STAFF REPORT: DECEMBER 10, 2025 REGULAR MEETING
APPLICATION NUMBER: HDC2025-00657 & HDC2025-00689
ADDRESS: 1794 SEYBURN
HISTORIC DISTRICT: WEST VILLAGE
APPLICANT: DAVID JONES & NICHOLAS SEHY
PROPERTY OWNER: SEHY INVESTMENTS LLC
DATE OF PROVISIONALLY COMPLETE APPLICATION: 11/08/2025
DATE OF STAFF SITE VISIT: 11/21/2025

SCOPE: INSTALL REAR DECK*, INSTALL CONCRETE DRIVEWAY AT REAR

Updated drawing of deck provided by applicant

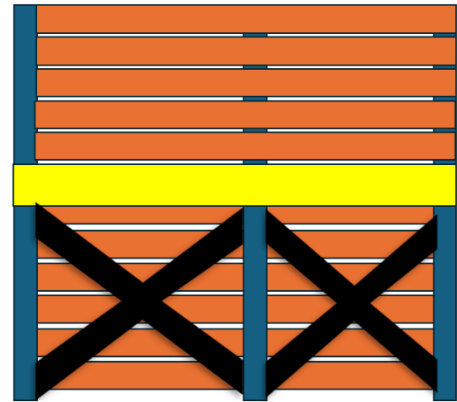
- The deck addition exceeds the height of the 6'-0" neighboring fence. Its contemporary style, which has a continuous privacy wall, is inconsistent with the neighboring architectural styles. There are 2" gaps between the horizontal wood boards. Typically, contemporary wood decks will have a recessed the lower level as well as larger gaps between the wooden panels, to limit visual interference with the historic house.

- It is Staff's opinion that the current design of the deck is not appropriate for the historic character of the neighborhood.
 - (10) *New additions and adjacent or related new construction shall be undertaken in such a manner that if removed in the future, the essential form and integrity of the historic property and its environment would be unimpaired.*

- Staff recommends that the deck should be redesigned to be more transparent and with a recessed base, to eliminate its adverse impact on the historic property and district.

- The deck as built visually interferes with the historic house and should be redesigned to be more transparent and with a recessed base, to eliminate its adverse impact on the historic property and district.

Recommendation 1 of 2 – Denial – Install rear deck

- The deck as built visually interferes with the historic house and should be redesigned to be more transparent and with a recessed base, to eliminate its adverse impact on the historic property and district.

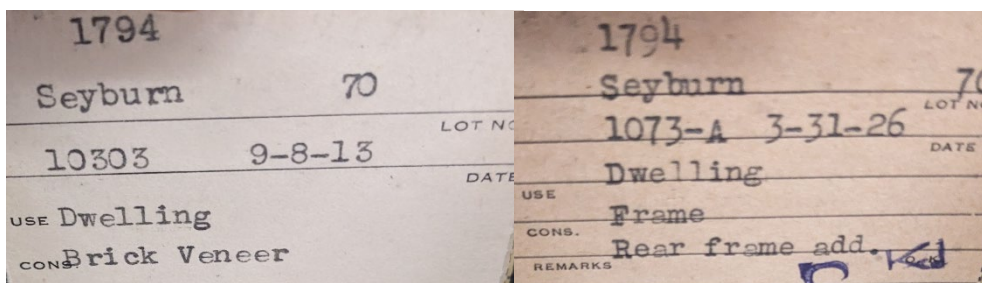
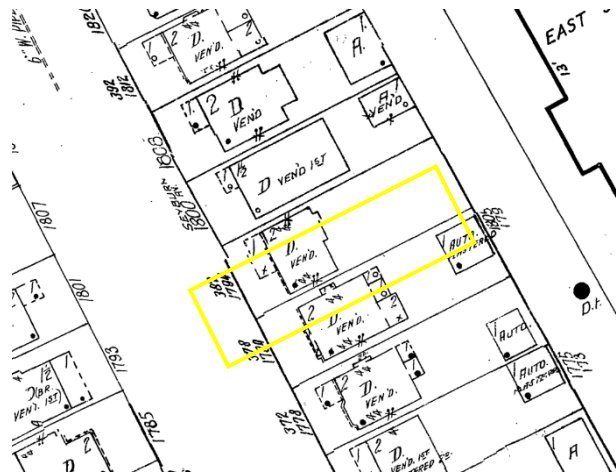
- Based on Google Street View images from July 2019, the wood shake has been repainted blue and some of the windows have been removed without HDC approval.
- Staff received a complaint about the construction of a new deck at the rear of the property. The addition of the wood deck is clearly visible from the Shipherd Street view.
